Subject: Written comments for 1/22/25 ZBA hearing regarding 520 Soule Blvd.
Attachments: Objections to 520 Soule Variance.pdf; 1st floor, existing, annotated.jpg; Postcard, reverse.PDF; NewStructuresPowerlinesBrochure.pdf

OBJECTIONS TO THE VARIANCE REQUESTED FOR 520 SOULE BLVD.
Submitted for the ZBA Hearing on 10/22/25

ZBA25-0032; 520 Soule Boulevard

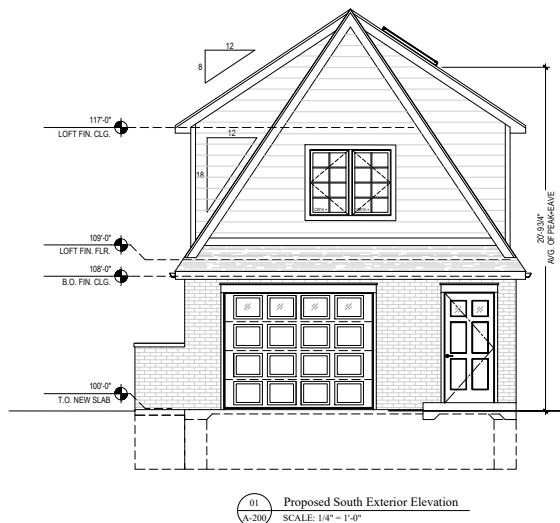
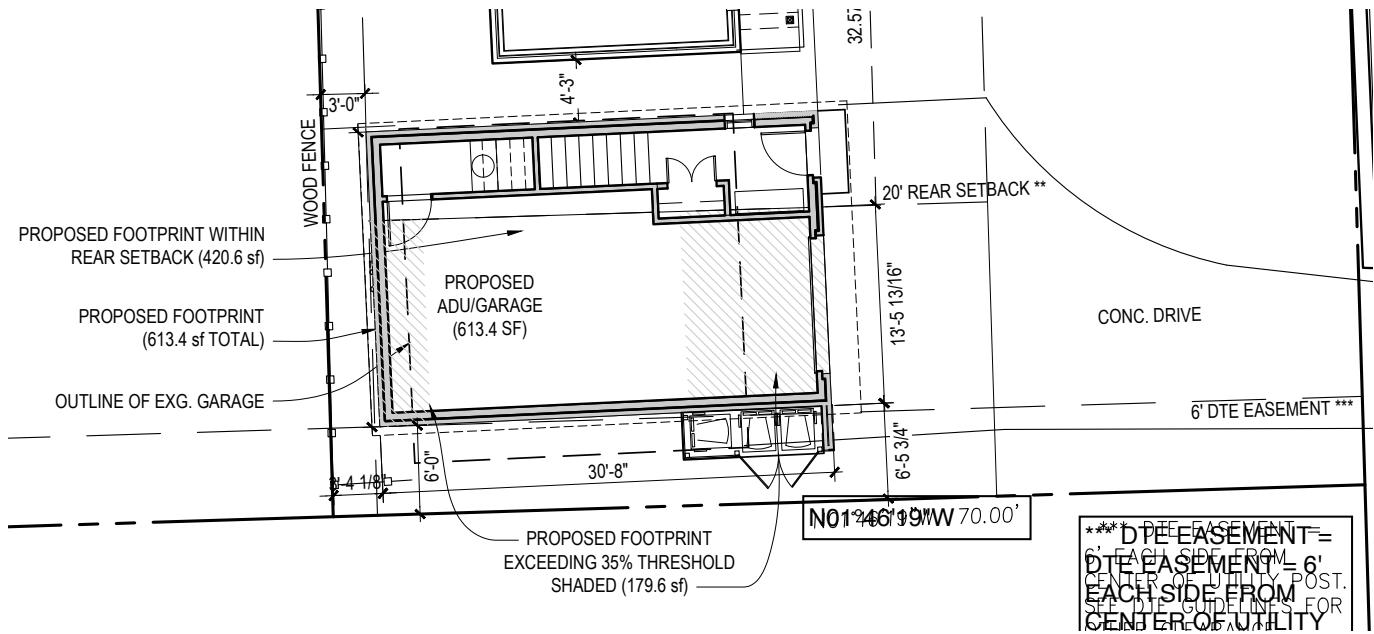
B. The proposed plan would violate DTE's prohibition against installing permanent structures in DTE's 6' utility easement. It may also violate DTE's rule requiring that buildings be at least 15' from the electrical lines.

The Applicants state that DTE has a utility easement on their lot that extends 6' from the rear lot line into their lot. (See site plan, G-002.)

DTE rules prohibit Applicants from installing any permanent structures in DTE's 6' easement.

The proposed structure would violate DTE's rule, because the permanent structures surrounding the garbage cans would extend well into DTE's 6' easement. The structures that would extend into DTE's 6' easement include the brick wall that projects westward from the front of the garage, the fences surrounding the refuse cans, and the fence doors. (See site plan G-002, and the Proposed South Exterior Elevation shown on A-200 and A-201.)

The Applicants are therefore prohibited from building the proposed projecting brick wall, the fence walls, and the fence doors.

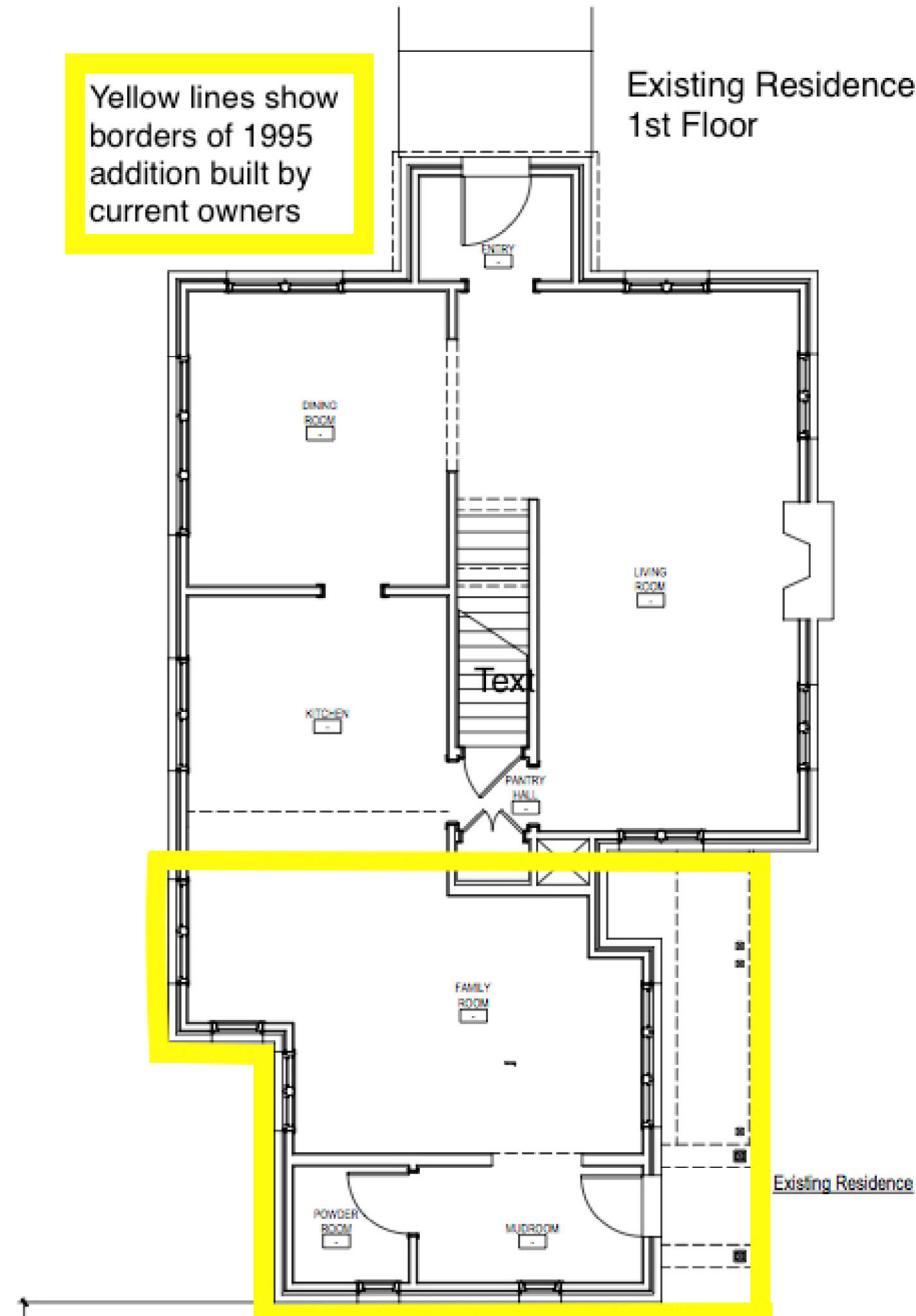
F. The proposed garbage area is so close to our lot line that it cannot possibly be utilized without the Applicants trespassing onto our property every time they access or move the trash bins, thereby destroying a significant part of our established garden and violating our property rights.

It is implausible to think that the Applicants can utilize the garbage area without coming onto our property and trammeling on our garden every time they attempt to move the bins in and out of the space. Refuse bins do not turn at 90-degree angles. They require more space to be maneuvered than the proposed design allows.

The tightness of the refuse area is more evidence that the lot is too built out.

There isn't even enough room for waste bins on the lot.
